SUBJECT: MLK Motor End Plates Improvement

Affected Products: All MLK & HLK Hoist Models and Motor Assemblies

Affected Date Range: All units built after July 2019

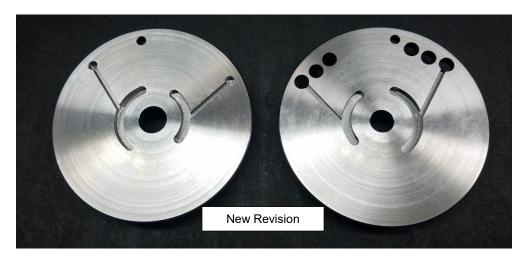
As a running change, Ingersoll Rand is updating the Motor End Plates on all MLK and HLK hoists. Part numbers 03193091 (MR-12) and 03193075 (MR-11) will not change. Old and new end plates can be used interchangeably.

There is/was no functional or quality issue that required the update of the motor end plates. It is solely a manufacturability update only. The concept is the same as is used on the CLK-Series hoist motor end plates and was proven to produce equivalent performance with the prior design before being implemented. The two existing air channels have been exposed on the surface of the end plates as shown in the "New Revision" photo below.
